**SUBJECT:** Southern California Edison Company's Response to Notice of Non-Performance (NON\_PAD\_SCE\_SIS\_20260114\_1300)

Notice	#	Structures
NON_PAD_SCE_SIS_20260114_1300	1	1392823E

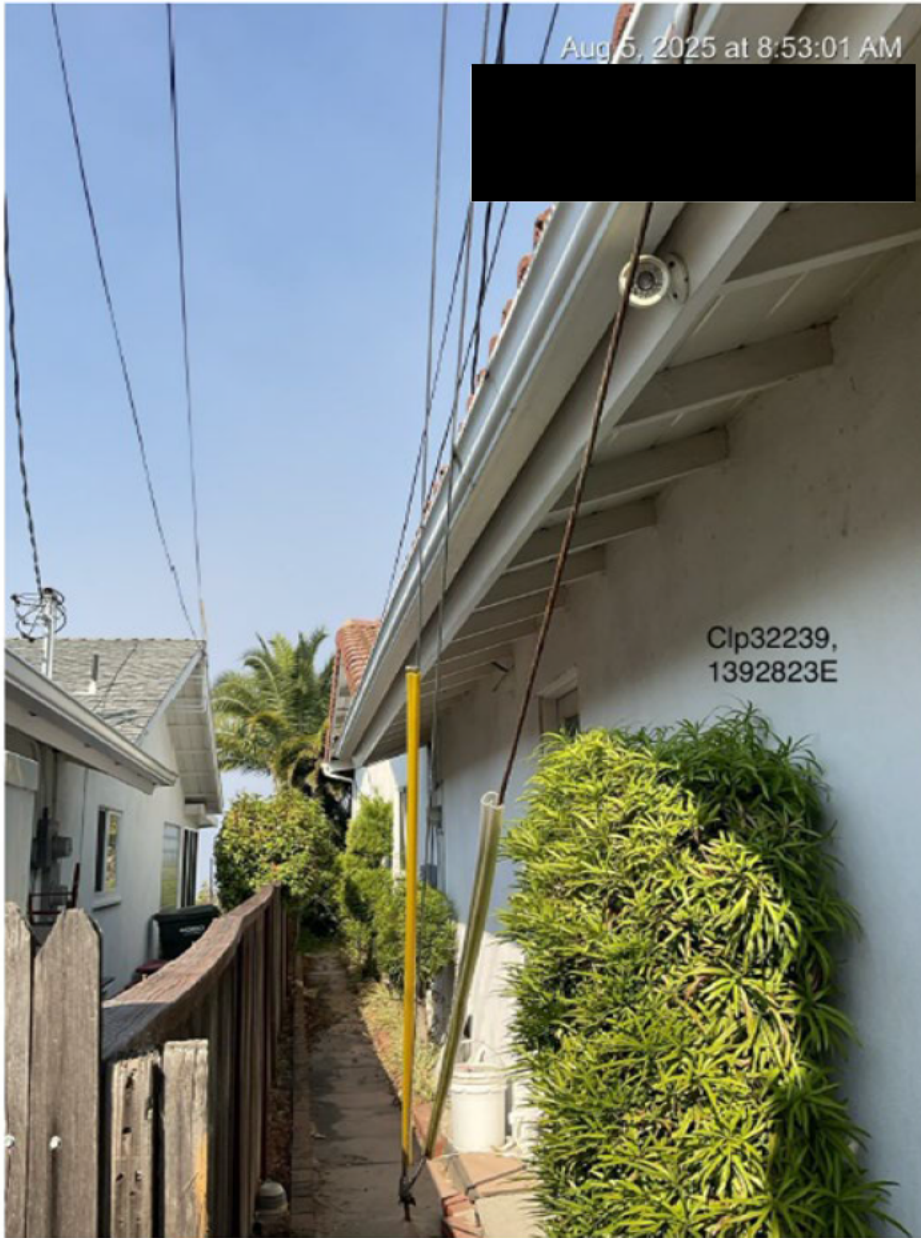
Energy Safety’s Notice states that in implementing its 2025 WMP initiative 8.1.3.1 - Distribution High Fire Risk-Informed (HFRI) Inspections and Remediations (IN-1.1), SCE failed to complete clearance of down guy on Pole ID 1392823E, Grid Hardening ID 414093121-1392823E at coordinates 33.7797146678882, -118.395505159758.

SCE confirms that the installation of a new guy anchor on structure 1392823E was completed on August 5, 2025. Please find photo evidence below of the guy anchor installation from August 5, 2025. SCE acknowledges that the relevant guy wire should have clearance from the rain gutter and plans to coordinate with the homeowner to

obtain property access and complete such clearance.
